Mitsubishi Motors North America, Inc.

TECHNICAL SERVICE BULLETIN

HOOD FLUTTER MY 2022 OUTLANDER

No: TSB-26-42A-002

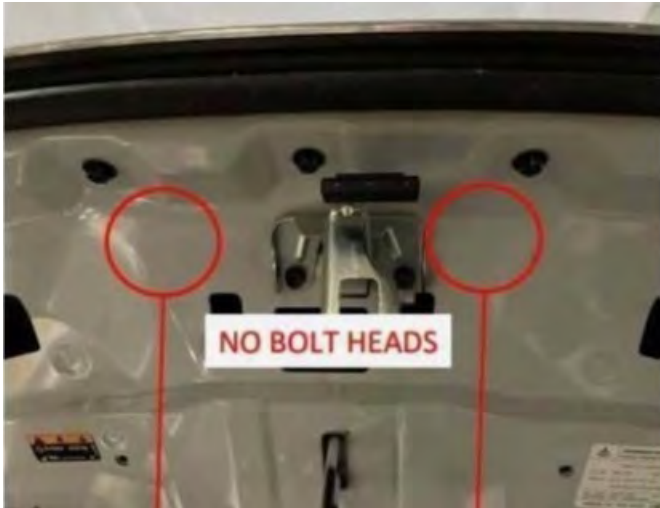
All vehicles equipped with a NON REINFORCED hood will require the engine hood to be replaced with the updated reinforced hood design.

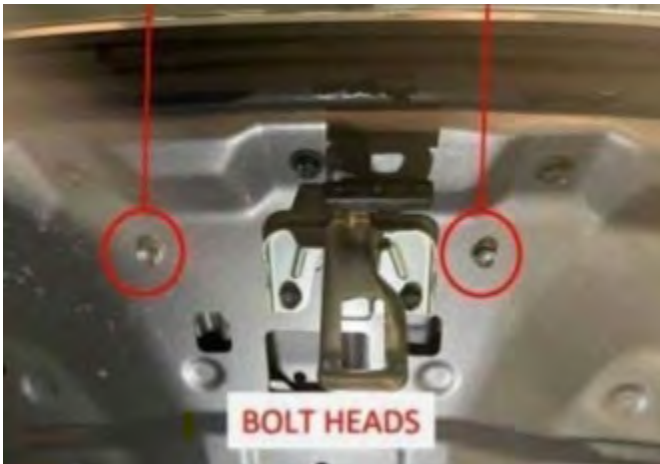
NON-REINFORCED hood: No bolt heads visible → Hood replacement is required.

REINFORCED hood: Bolt heads visible → Hood replacement is **not required.**

Any 2022 Outlander with a NON-reinforced hood **MUST** receive an updated reinforced hood, regardless of any previous repairs performed at a Mitsubishi dealership for hood flutter issues including hood replacements with a NON-reinforced hood.

HOOD REPLACEMENT

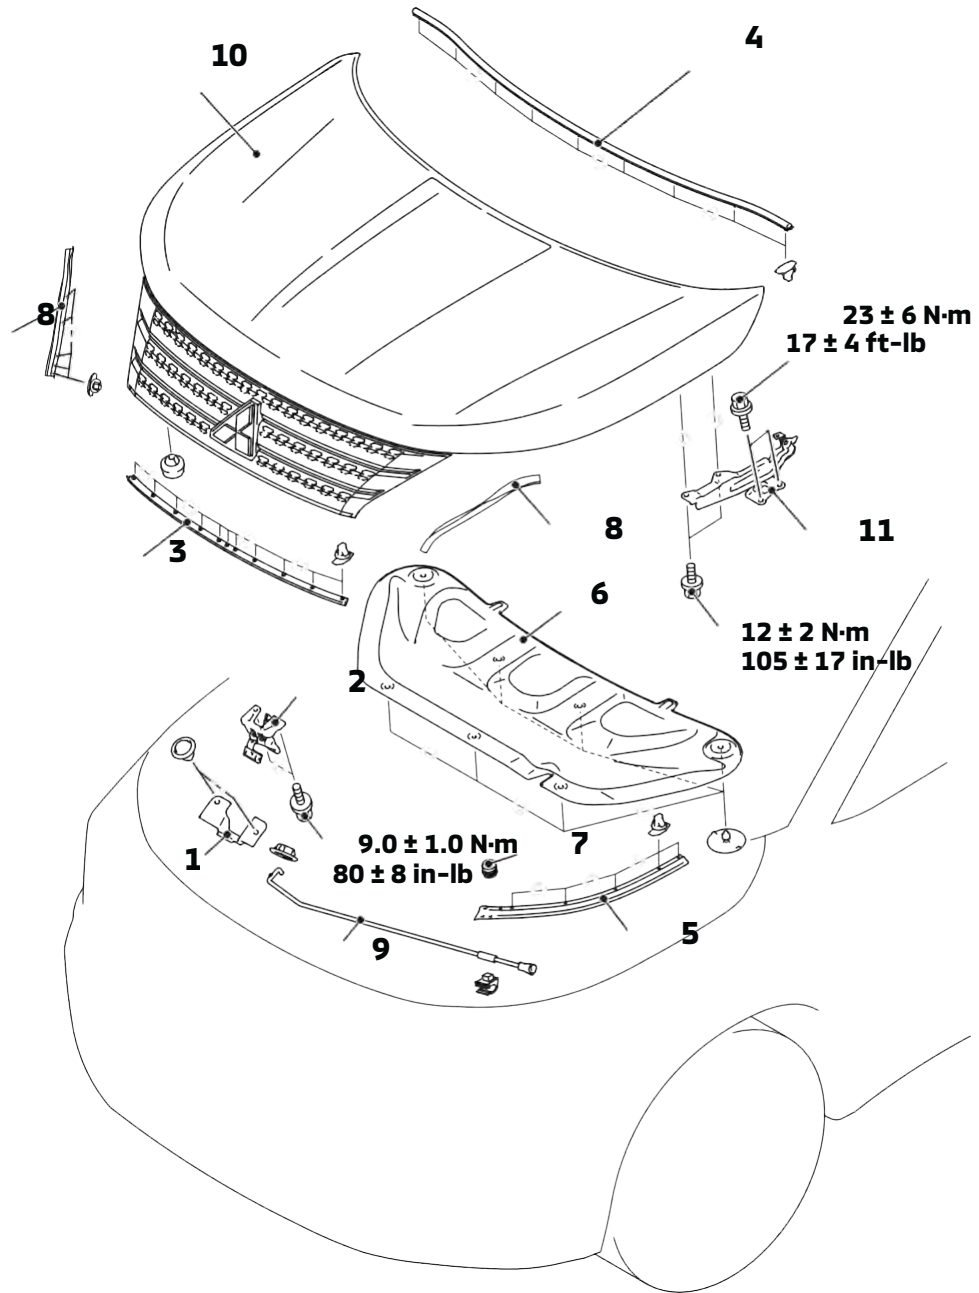
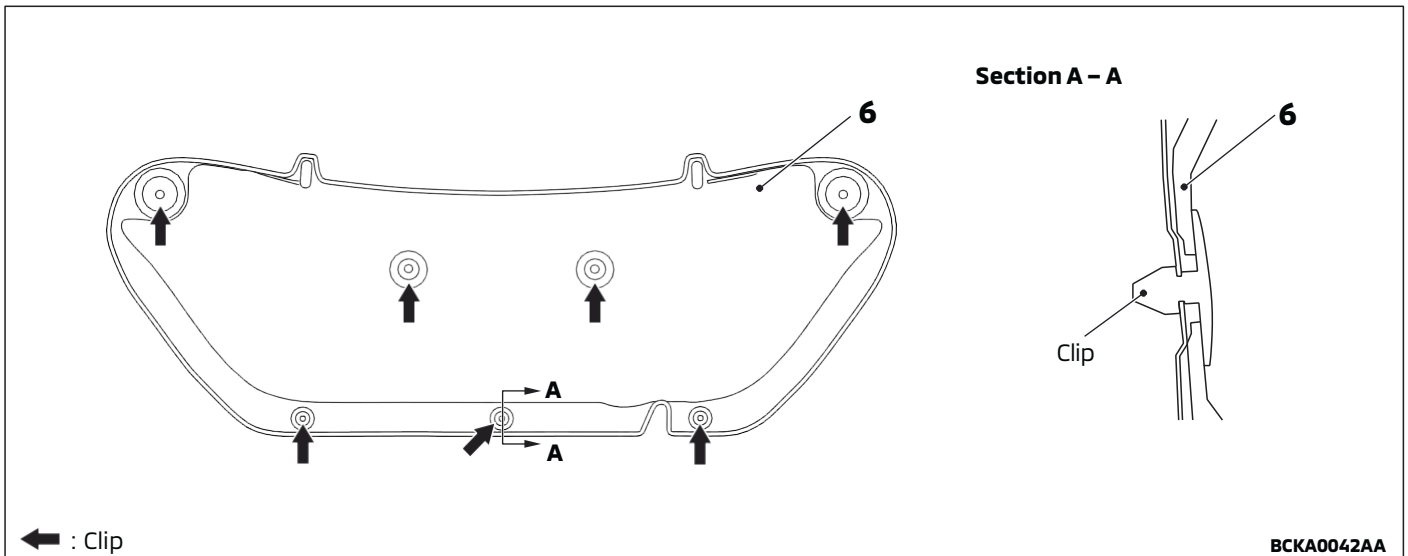
Removal step
1.	Secondary lever cover
2.	Secondary lever
3.	Hood front weatherstrip
4.	Hood rear weatherstrip
5.	Hood front side weatherstrip
6.	Hood insulator
7.	Hood damper
8.	Hood grille weatherstrip
9.	Hood support rod
10.	Hood
11.	Hood hinge

ADJUSTMENT OF CLEARANCE OF THE HOOD

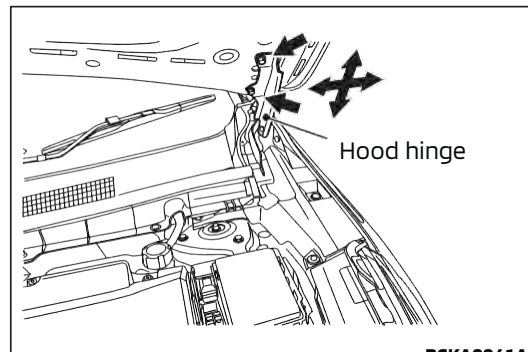
1. Loosen the hood hinge mounting bolts but do not remove them. Move the hood hinge back/forth and left/right to align the clearance between the hood and body.
2. After the adjustment, tighten the hood hinge mounting bolts specified torque.

Tightening torque:
 $12 \pm 2 \text{ N}\cdot\text{m}$ ($106 \pm 17 \text{ in}\cdot\text{lb}$)

ADJUSTMENT OF HOOD LEVEL AND HOOD STRIKER ENGAGEMENT

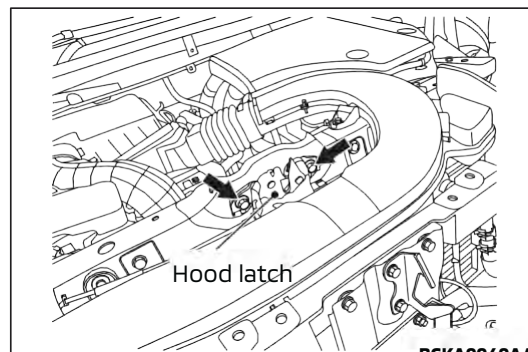
1. Loosen the hood latch mounting bolts but do not remove them. Move the hood latch up/down and left/right to align the hood level and adjust the hood striker engagement.
2. After the adjustment, tighten the hood latch mounting bolts specified torque.

Tightening torque:
 $21 \pm 1 \text{ N}\cdot\text{m}$ ($15.5 \pm 0.7 \text{ ft}\cdot\text{lb}$)

ADJUSTMENT OF HOOD HEIGHT

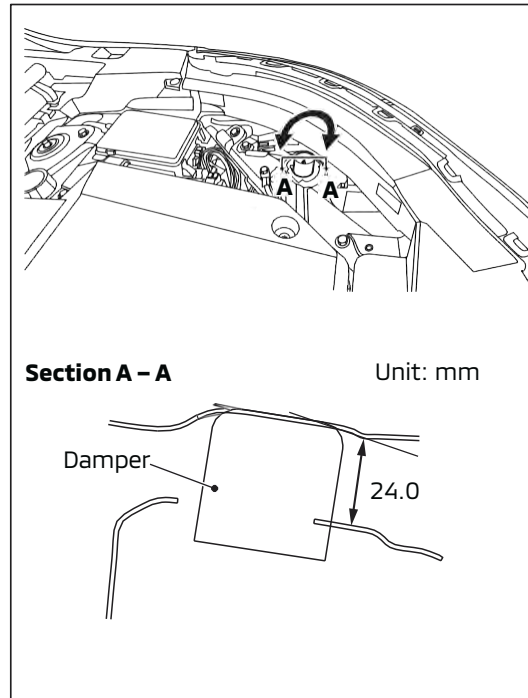
Turn the damper to the dimension shown in the figure to adjust the hood height. If the hood height is still not even, turn the damper again until the height is even. The damper height is altered by roughly 4 mm (0.2 inch) when the damper is rotated once.

If a rattling noise is heard due to the vibration of the hood when the vehicle is being driven, adjust the damper height until the damper is seated on the hood.
